***Approach for Response to TN-40 Transport
Application RAI
July 2, 2008***

Transnuclear, Inc.

Enclosure 3

20° Slapdown, First Impact

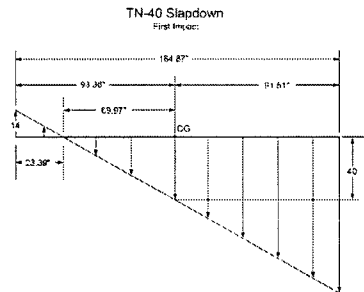
- ▶ ***RAIs 2-7, 2-9, 2-27, 2-28, 2-30, 3-13***
 - ◆ ***2-7 Provide overview of use of ADOC vs. test results***
 - ◆ ***2-9 Justify 20° slapdown angle as worst case***
 - ◆ ***2-27 Summary g-loads on page 2.10.7-11 should use 78g rather than 42g as shown***
 - ◆ ***2-28 Verify that the side-drop deceleration of 51 g is bounding***
 - ◆ ***2-30 Justify why the ADOC calculated transverse deceleration of 78g for the 20° slapdown is not used***
 - ◆ ***3-13 Demonstrate that the Impact Limiters remain firmly attached to the cask after 30 foot drop***

at Impact End due to Impact Force
 $= 11846/272 = 43g$

at Impact End = $43 \times \cos 20^\circ = 40g$

at Impact End = 90g

The transverse acceleration (40g) produces local impact loads

The rotational acceleration (50g) produces bending moment in the cask

► RAls 2-16, 2-17, 2-19 and 2-23

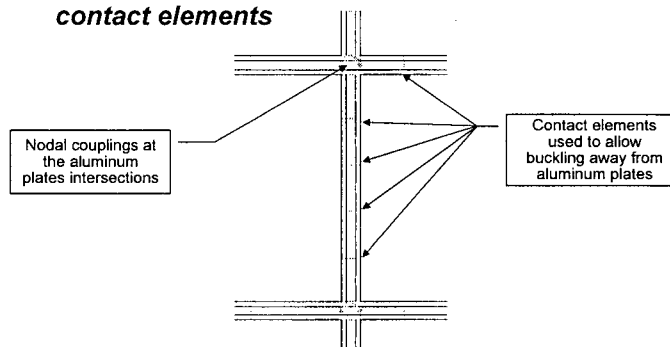
- ◆ *Justify nodal couplings don't result in unrealistically high flexural rigidity for the basket wall panel*
- ◆ *Show nodal coupling at the aluminum plates intersection*
- ◆ *Nodal couplings prevent the steel wall panel from buckling away from aluminum plates*
- ◆ *Justify the safety factors of 1.18, 1.23 and 1.24*

- ◆ *Sensitivity study of the buckling analyses was performed where nodal couplings were replaced by contact elements*
